# Map Correction-Field Verification

Drain Name: Centennial South Phase 2

RE: Williams Creek Drain, Centennial South Phase 2 Arm

#### **Re: Williams Creek: Centennial South Phase 2**

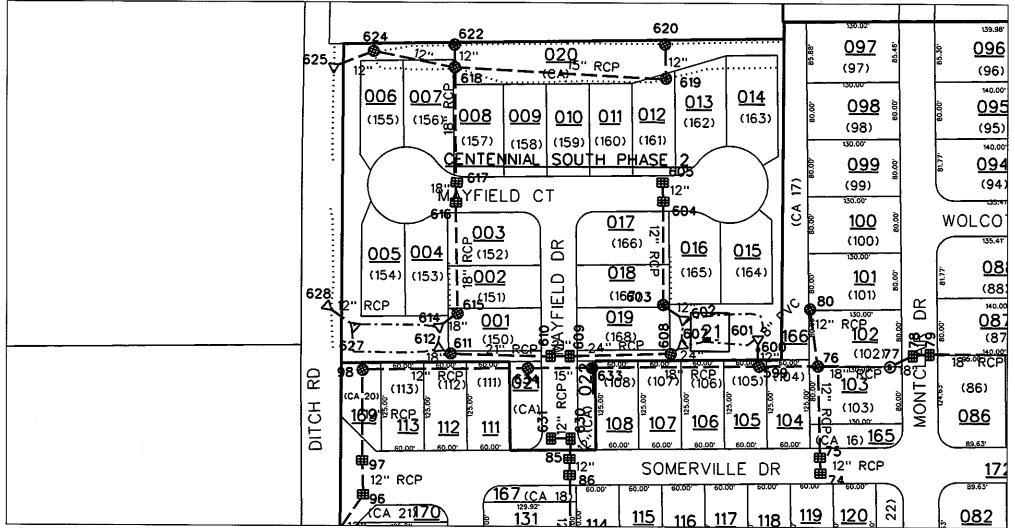
The SSD was improperly mapped under the curbs. The SSD under the curbs were not outlined as part of the regulated drain. The SSD outlined in the report were those in the common area and in the rear of lots152-151 and 166-167. Therefore, the length of SSD was shortened from 1898 feet to 1675 feet.

Change + / - : -223 New Length: 3431

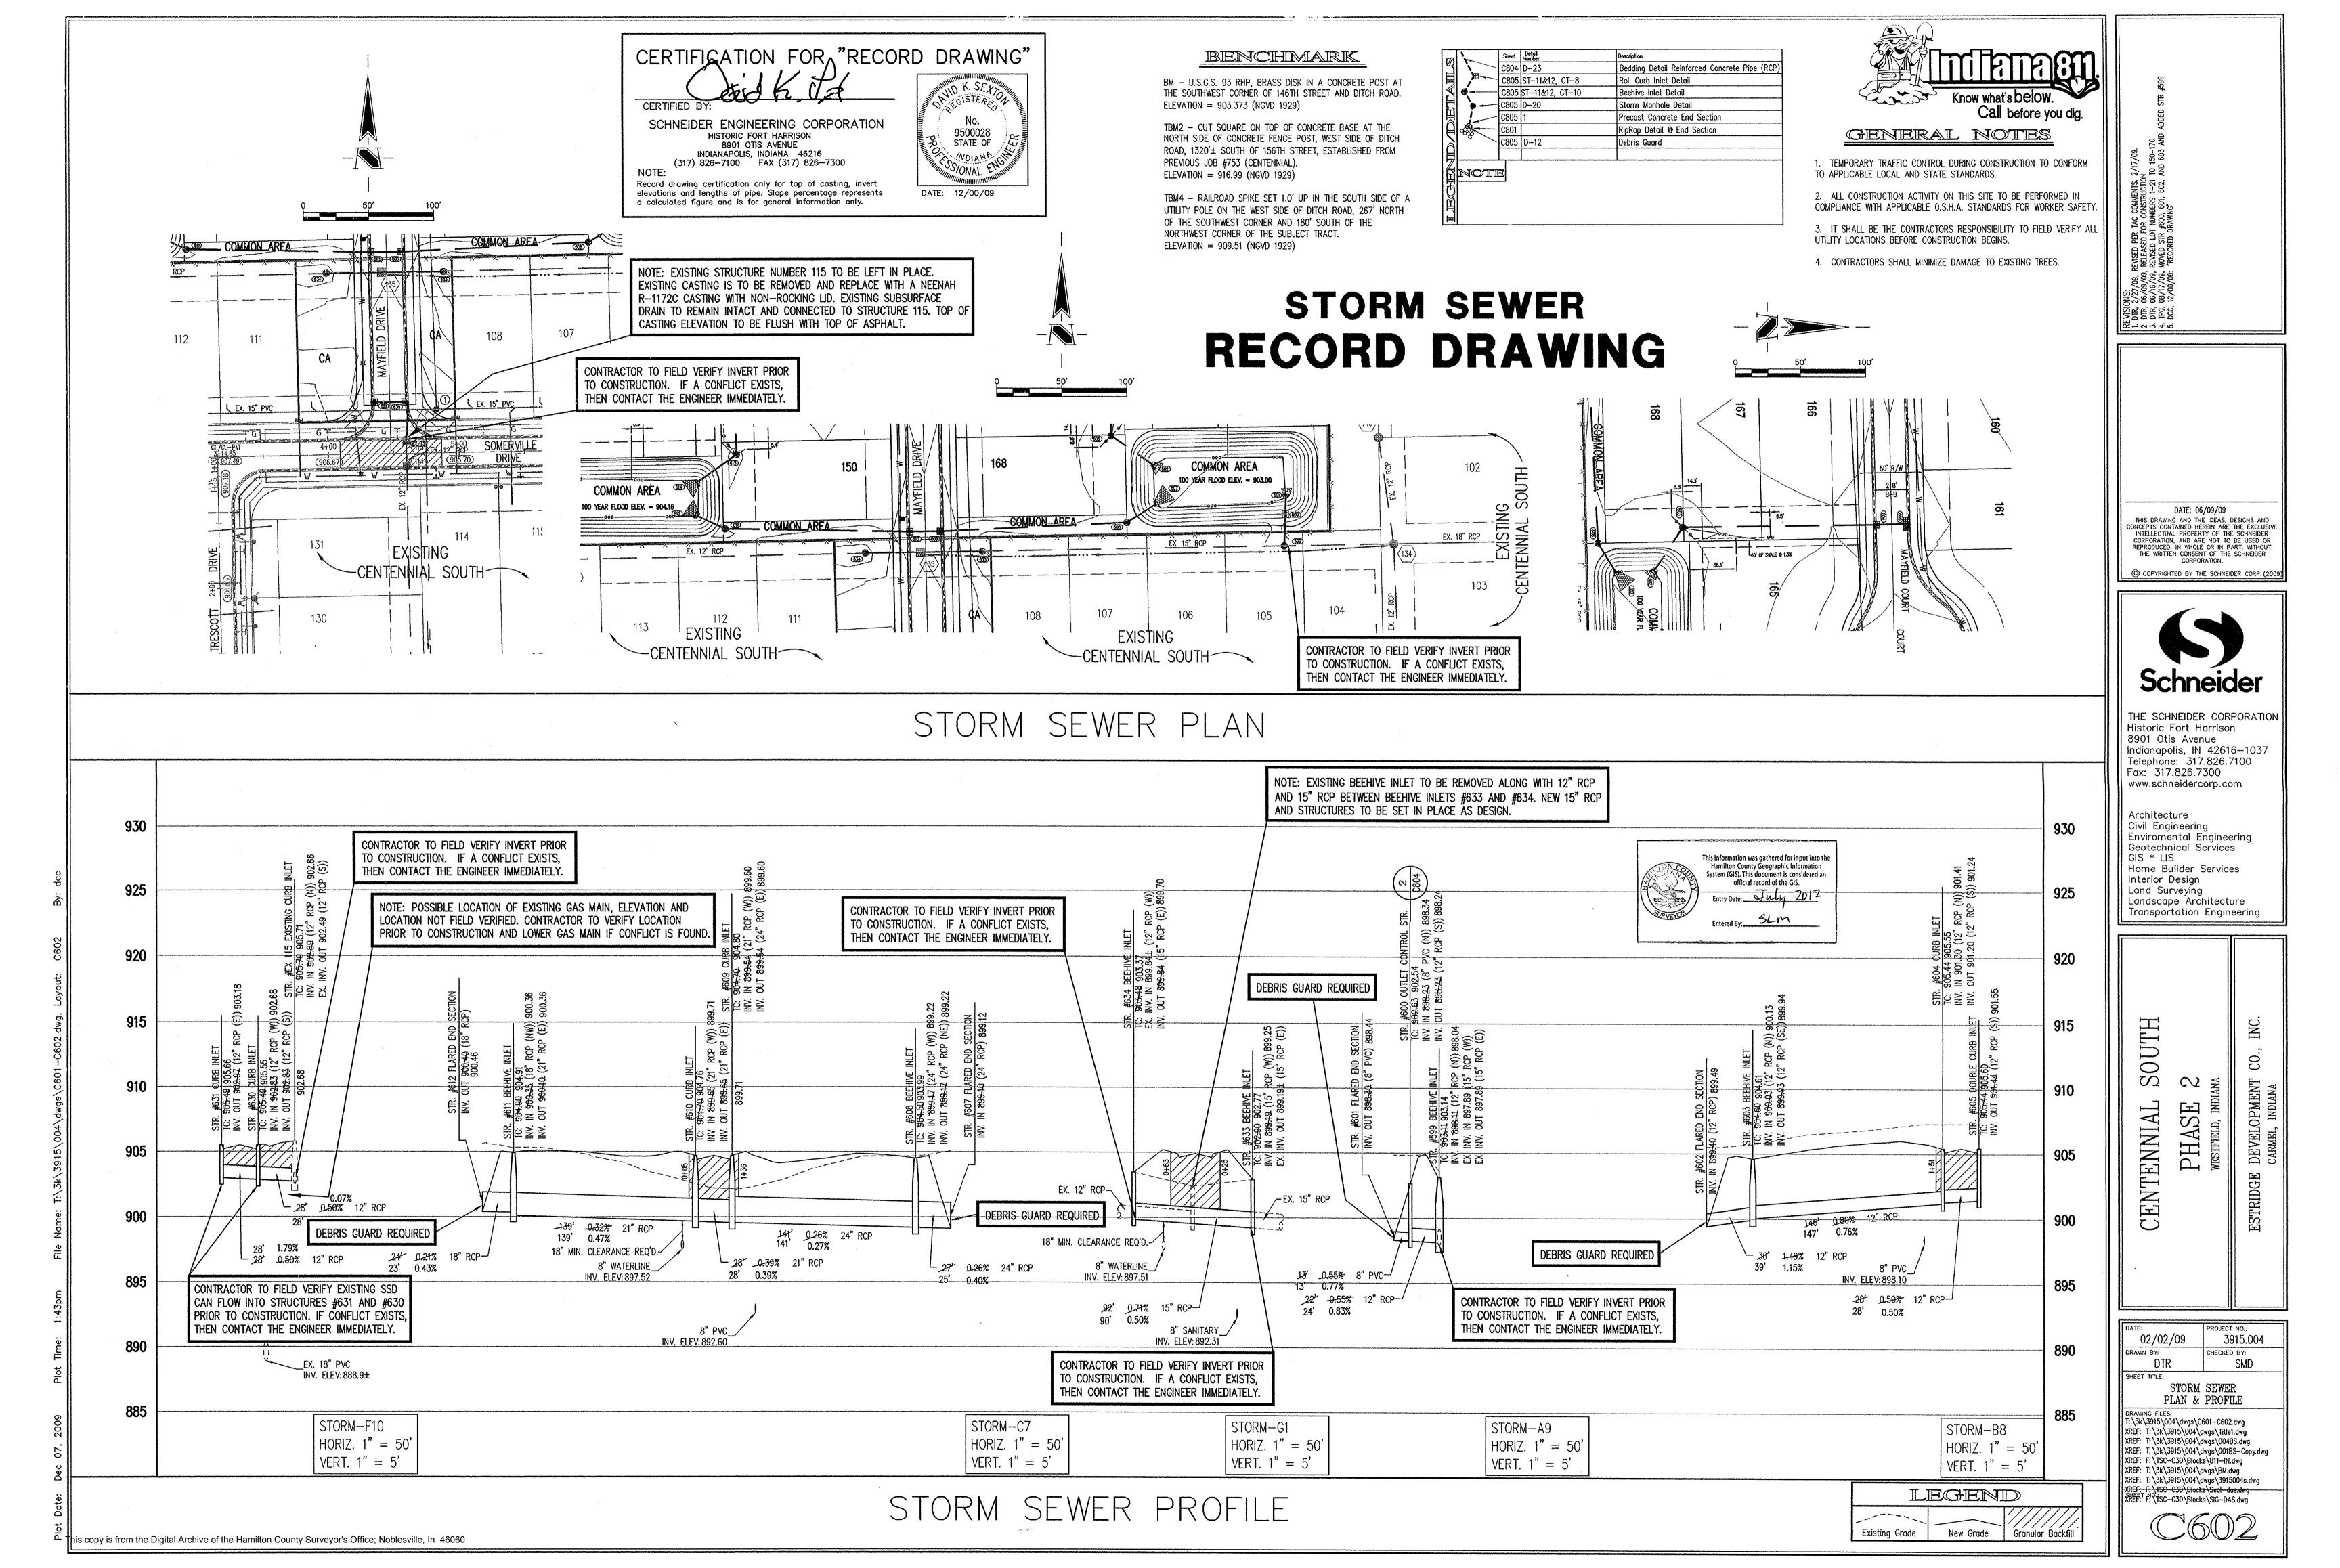
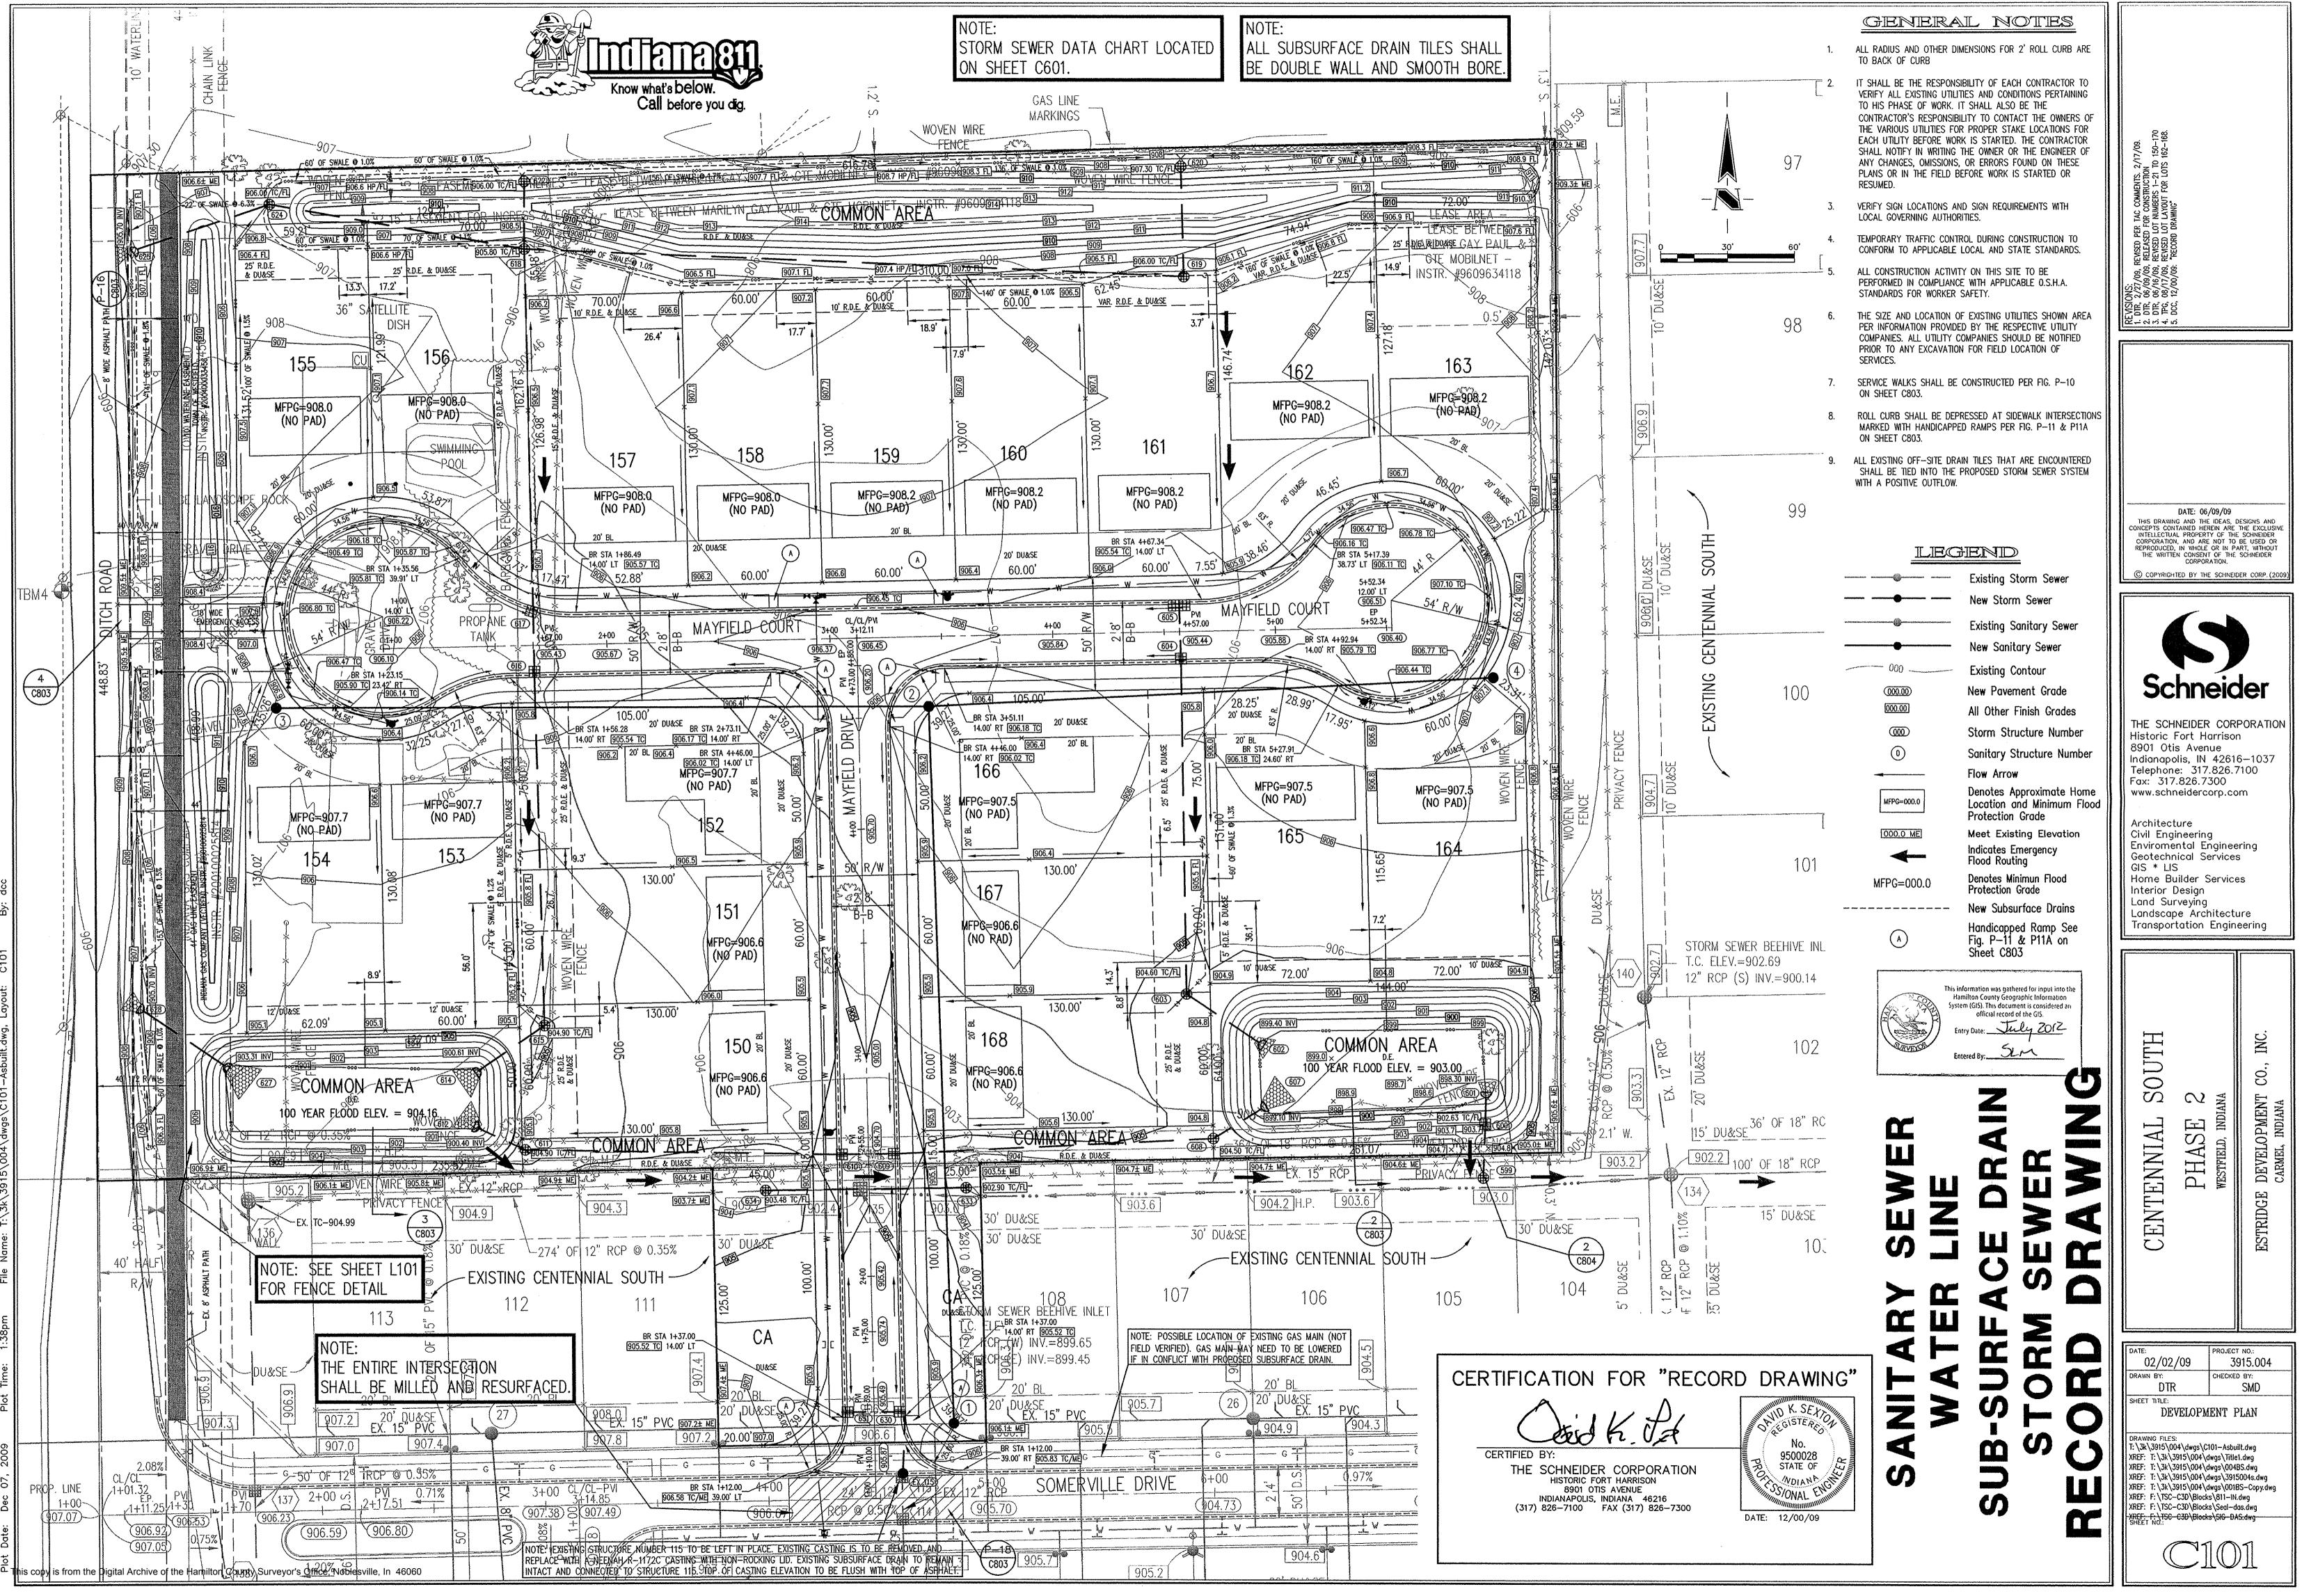
During construction, changes were made to the drain, which will alter the plans submitted with my report for this drain-dated September 1, 2009. The report was approved by the Board at the hearing held October 26, 2009. (See Drainage Board Minutes Book 12, Pages 311-312) The changes are as follows:

The 12" RCP was shortened from 623 feet to 598 feet. The 15" RCP was shortened from 388 feet to 386 feet. The 18" RCP was shortened from 406 feet to 403 feet. The 24" RCP was lengthened from 168 feet to 189 feet. The 6" SSD was lengthened from 1830 feet to 1898 feet. The length of the drain due to the changes described above is now 3,654 feet.
